**SUBJECT:** SP19-061, Site Plan, Horseshoe Ridge Block 1 Lot 1 – Learning Center Review Comments v3

## SITE PLAN REVIEW

PROJECT TITLE  
**THE LEARNING EXPERIENCE**

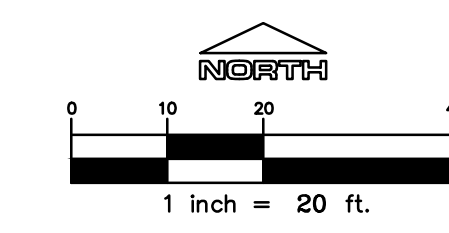
What is this symbol?  
Add to the legend.

Added as Sidewalk chase, is that right?

**1 PHOTOMETRIC SITE PLAN**  
 scale: 1"=20'-0"  
 NORTH

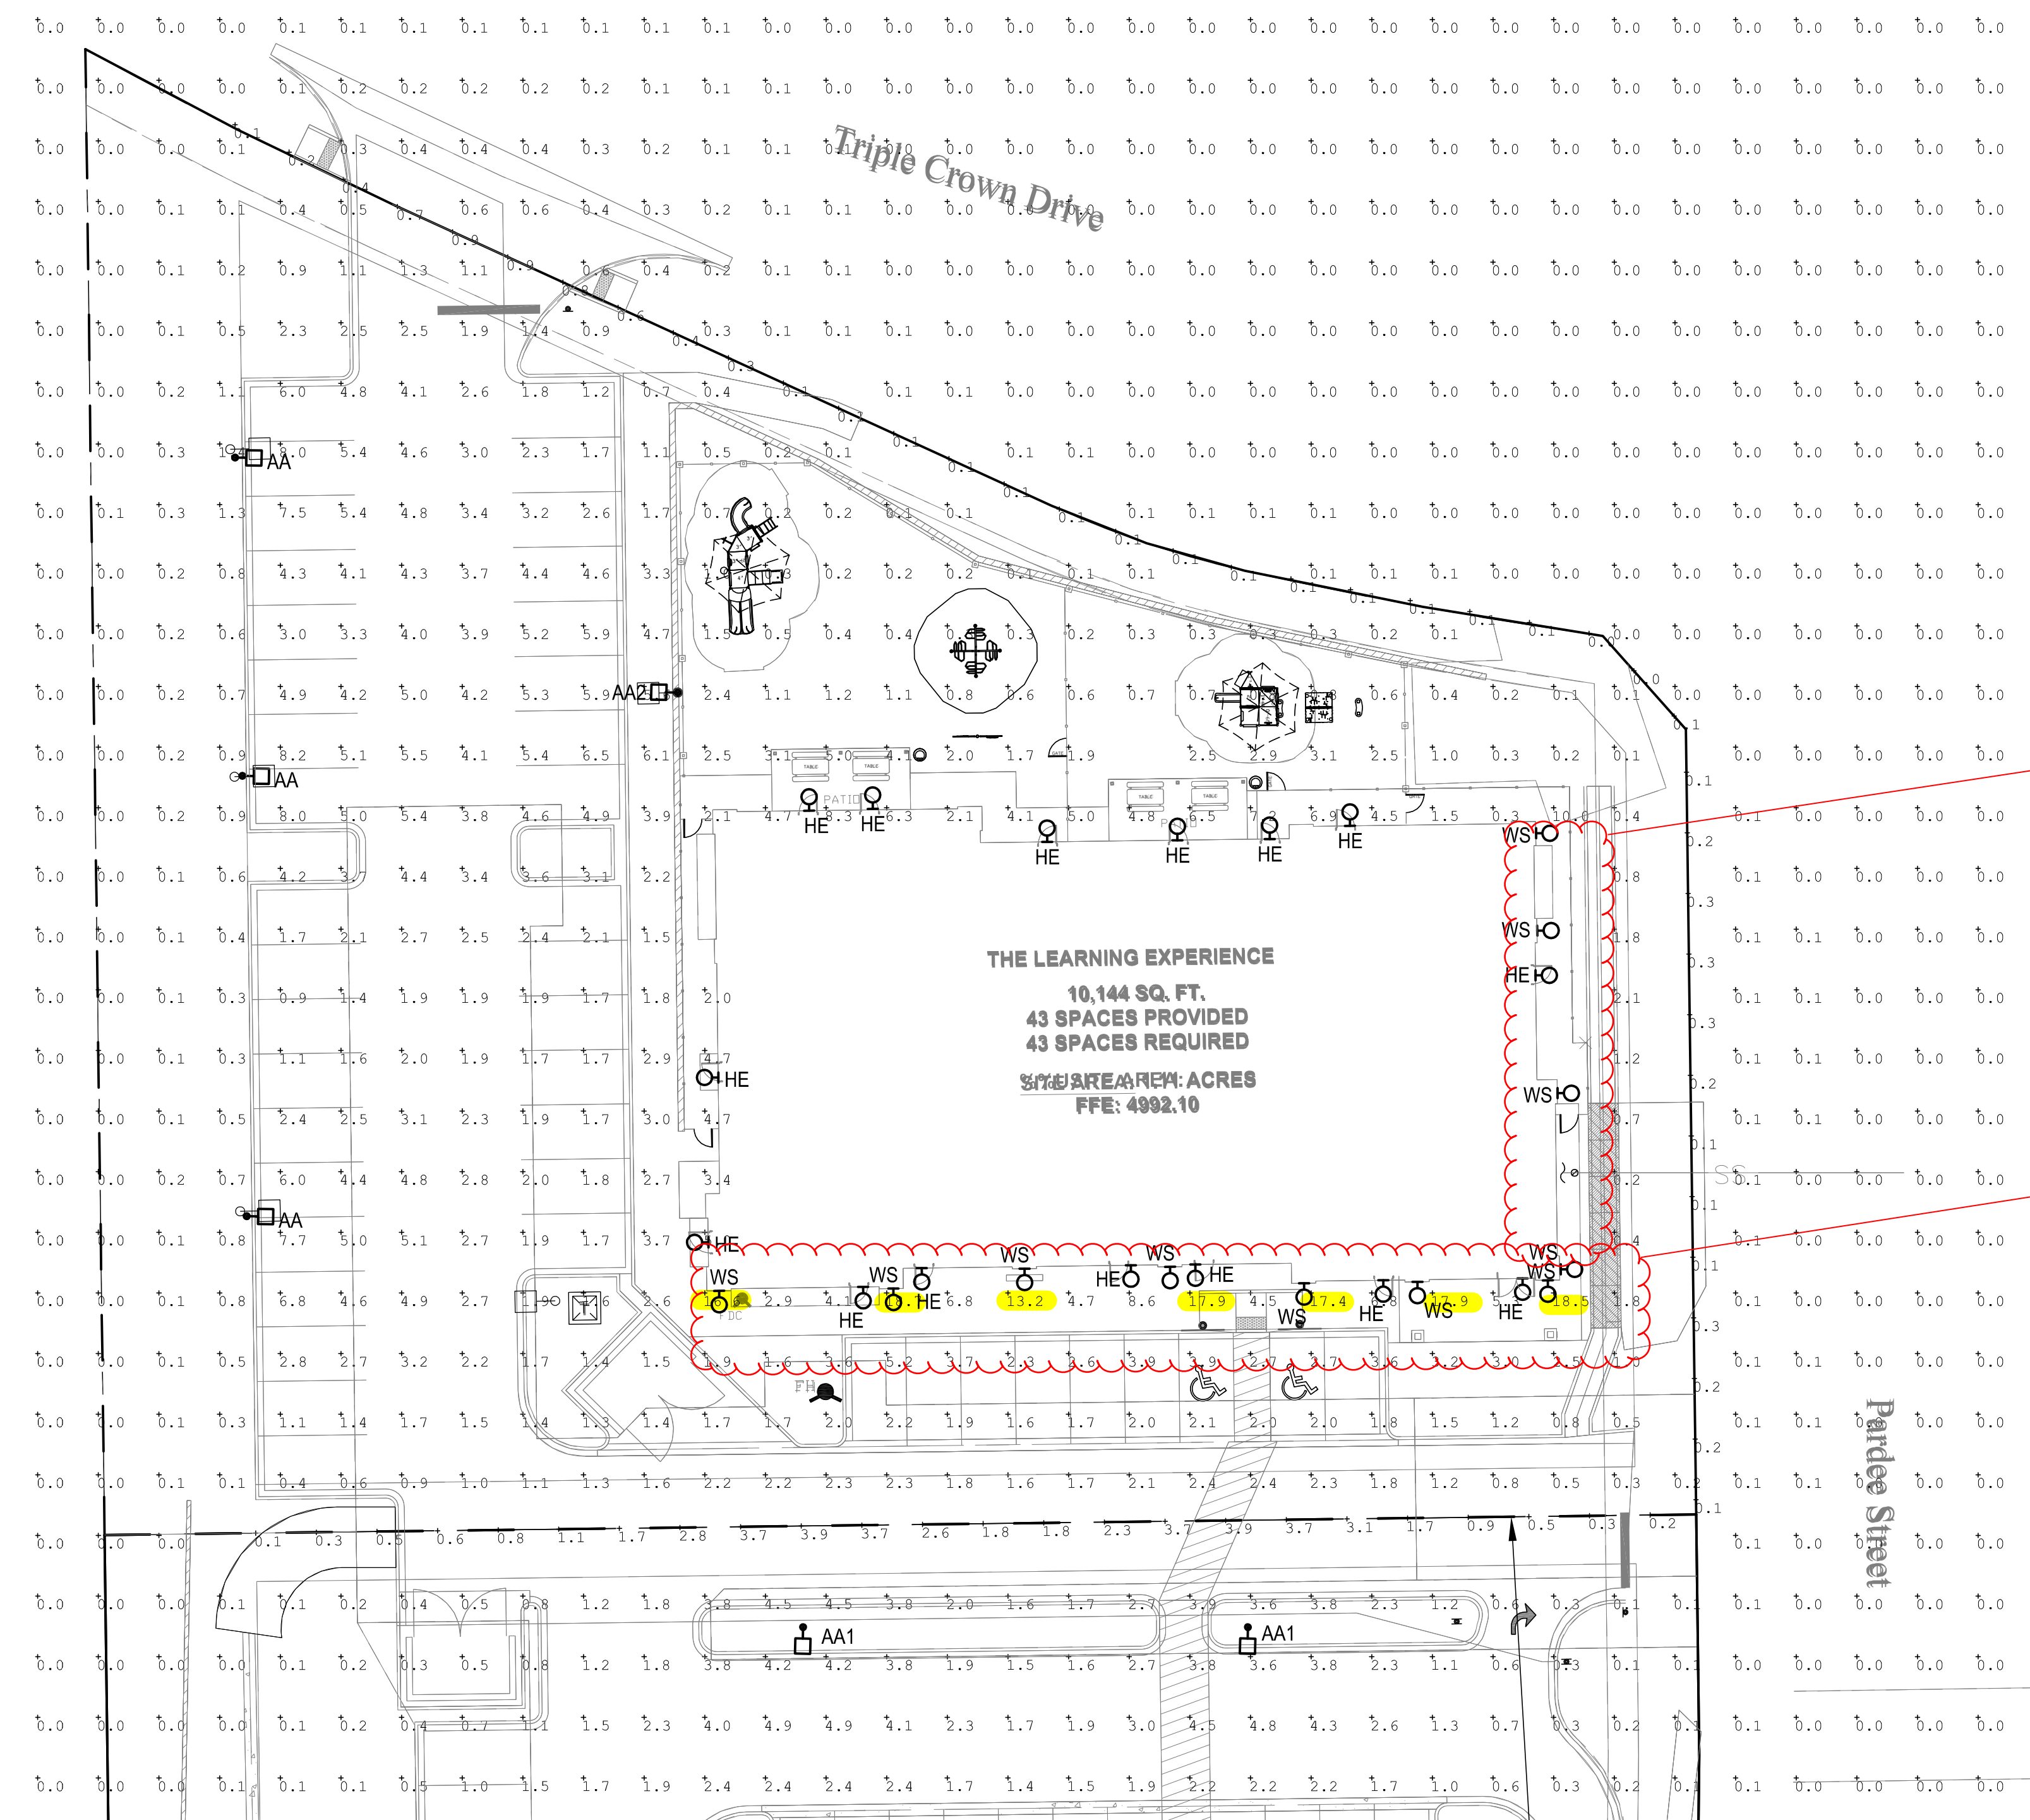
Per Section 13.10.140 for pedestrian safety and orientation, medium activity lots the maximum Uniformity Ratio (average to minimum) is 3:1. Please adjust accordingly.  
 Adjusted on amended plan

Per Section 13.10.140 for pedestrian safety and orientation, medium activity lots the maximum Uniformity Ratio (maximum to minimum) is 10:1. Please adjust accordingly.  
 Adjusted on amended plan

Provide the foot candles along the pedestrian walk way.  
 Provided on amended plan

Per Section 13.10.140 (e)(14) The maximum illuminance on any residential or nonresidential site (not including any site with a qualifying principal display area) is twelve point zero (12.0) foot-candles, maximum installed illuminance. Please adjust accordingly.  
 Adjusted on amended plan

SHEET TITLE  
**LANDSCAPE PLAN**

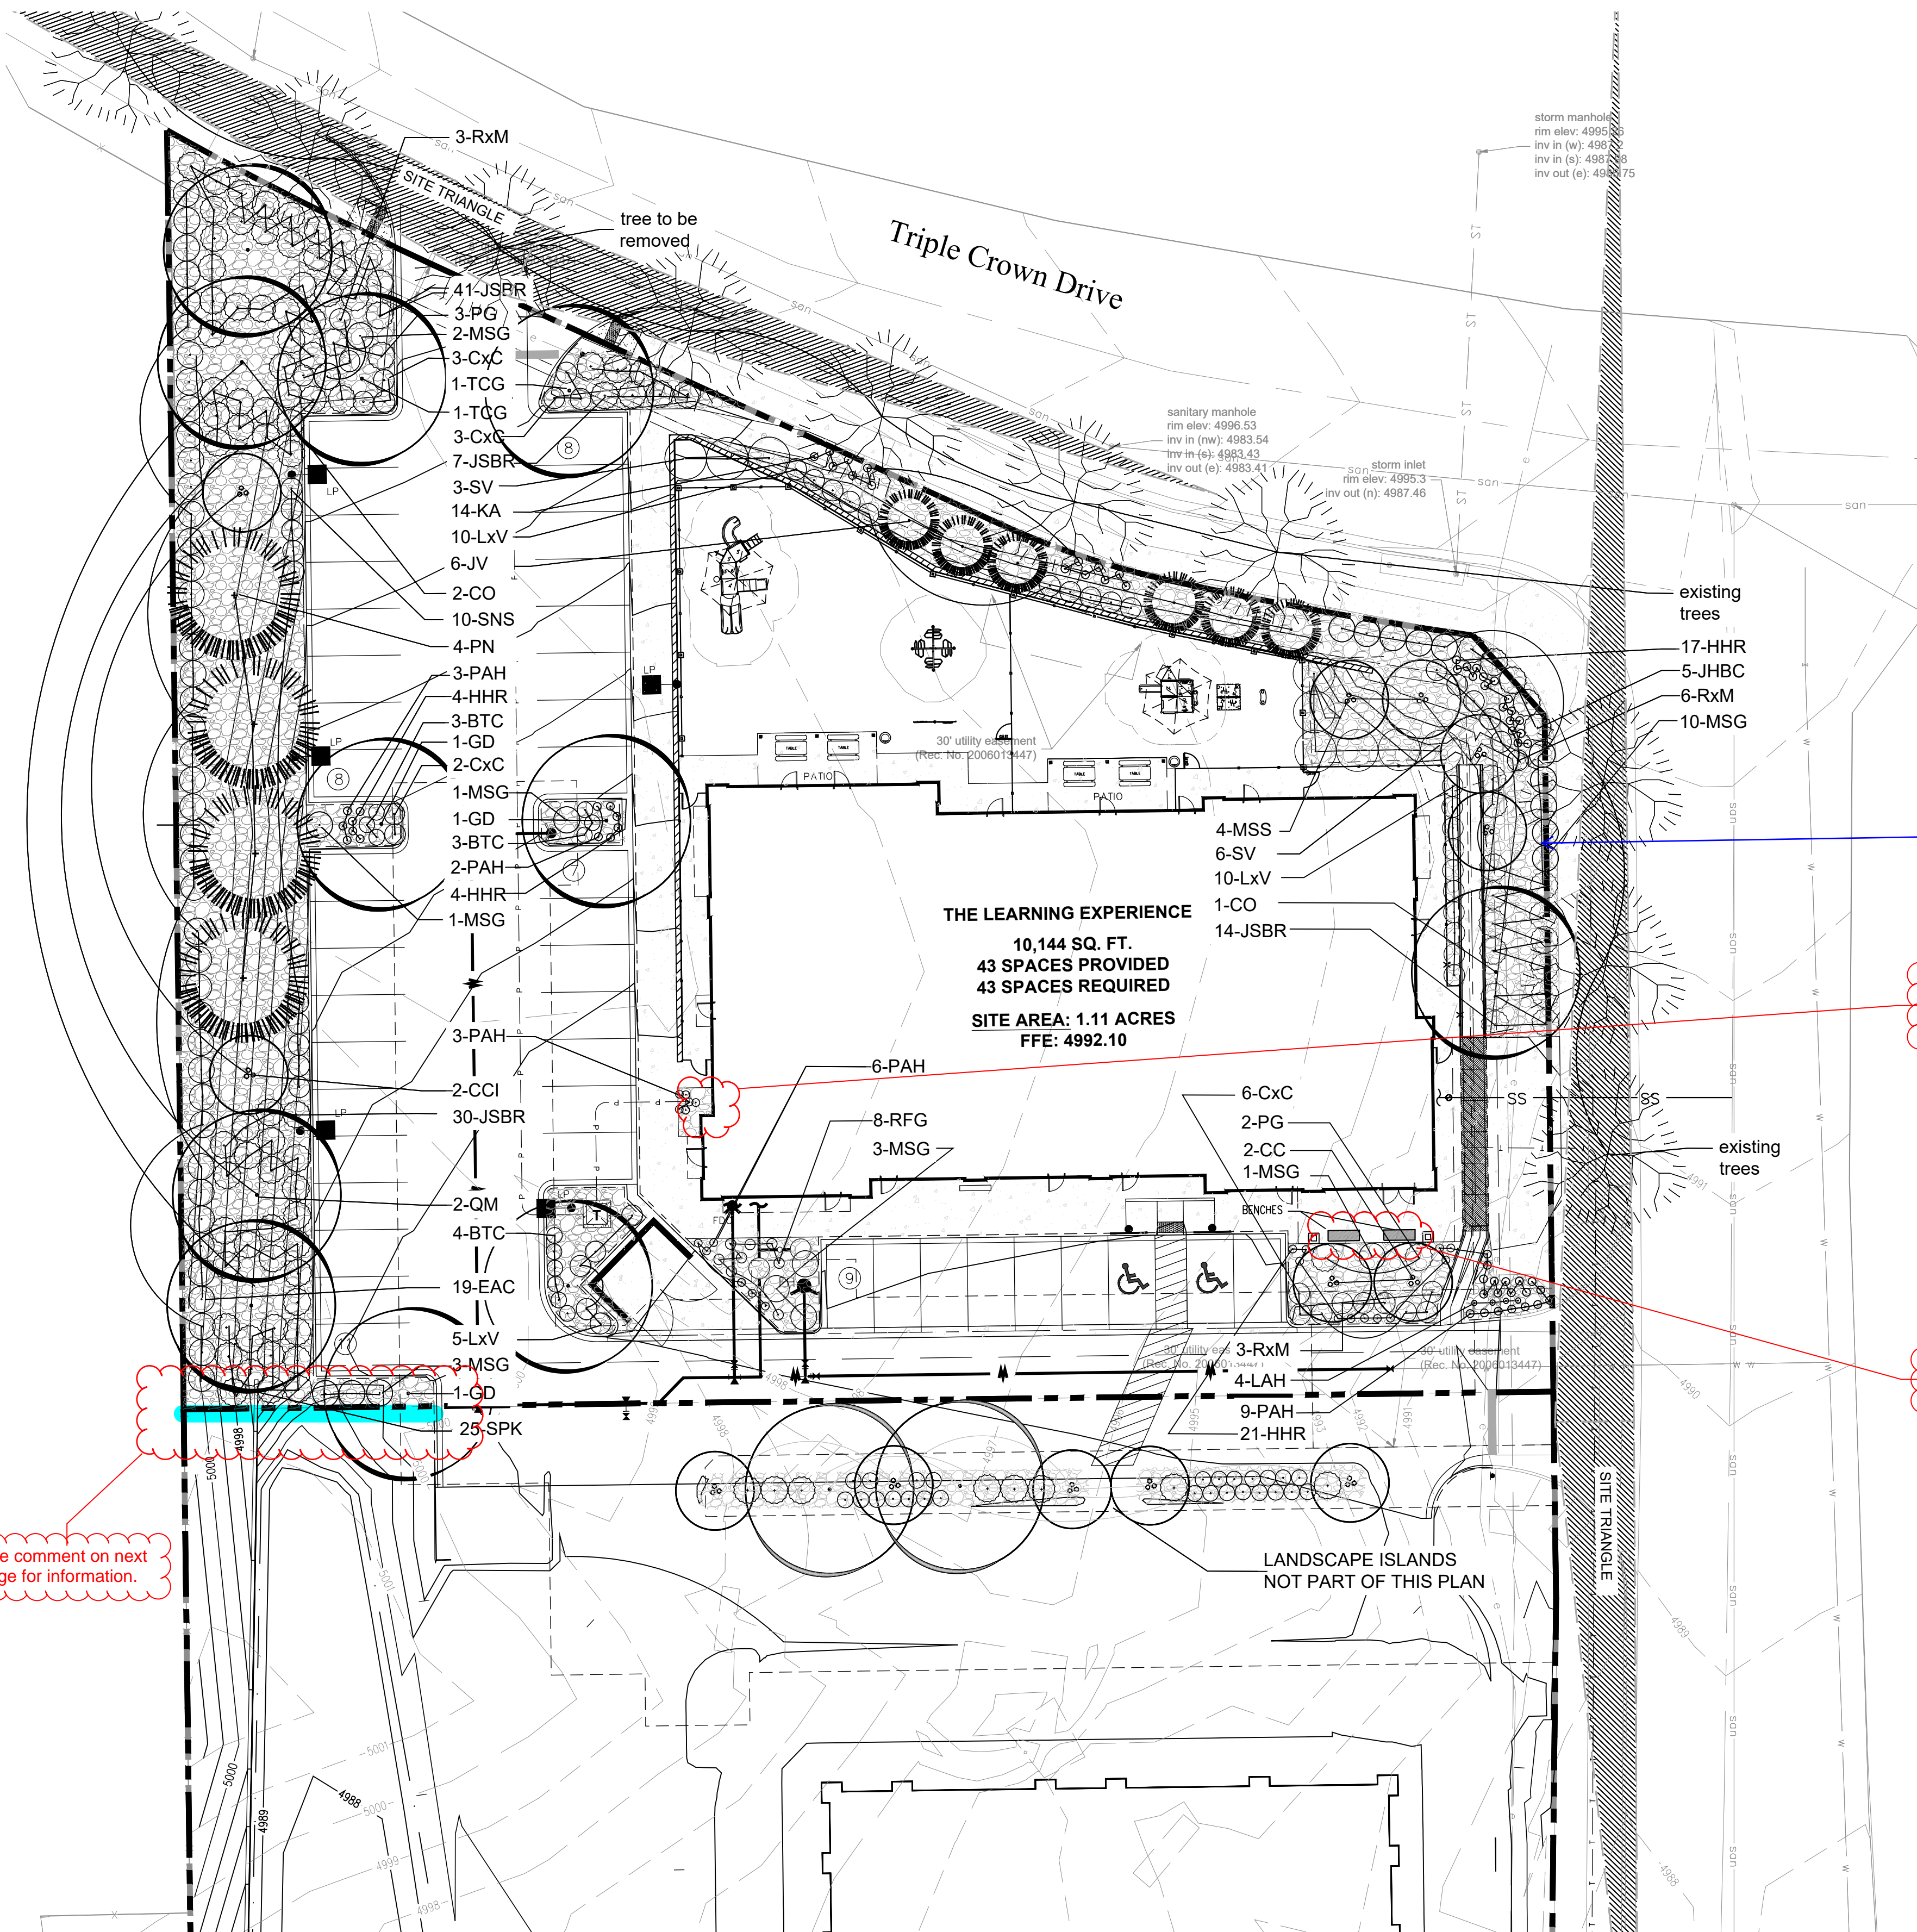
Where will the electrical cabinet be located on the site? Was shown in this location on the previous plans.

Show on site plan (page 2).

The Sight distance triangle is now correctly shown on the updated plans and the trees in the triangle have been removed and shrubs have been added to account for the tree requirement

A Conservation Plan for the ROW tree removal is included in the updated plan set

See comment on next page for information.

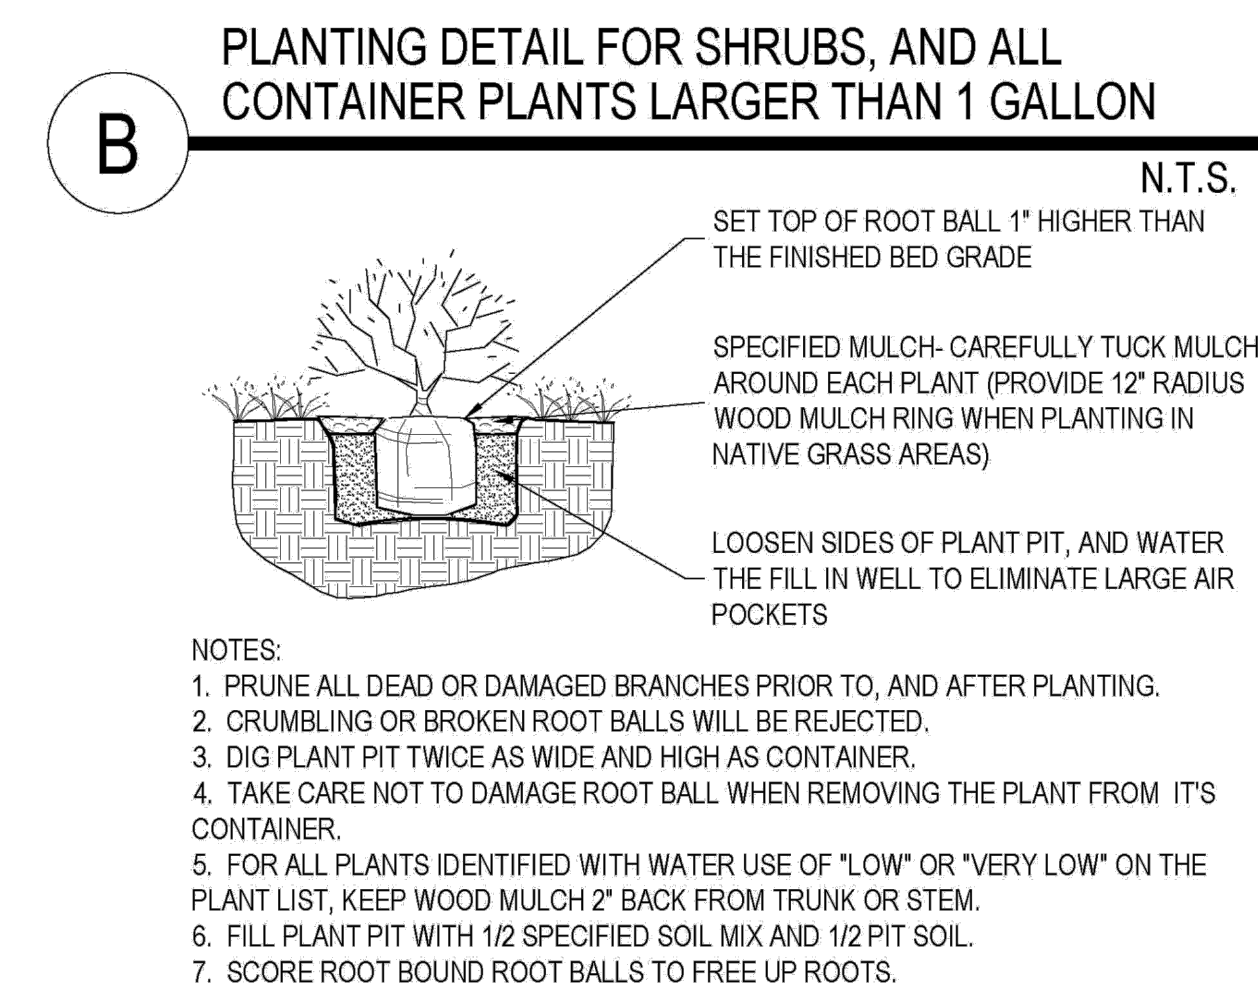
Staff is unable to waive any landscaping requirements. Please use the highlighted blue area on the previous page as your linear feet. This way the shared drive perimeter will not count against the total landscaped required. Please adjust accordingly and show all landscaping requirements have been met.

Addressed in updated plan
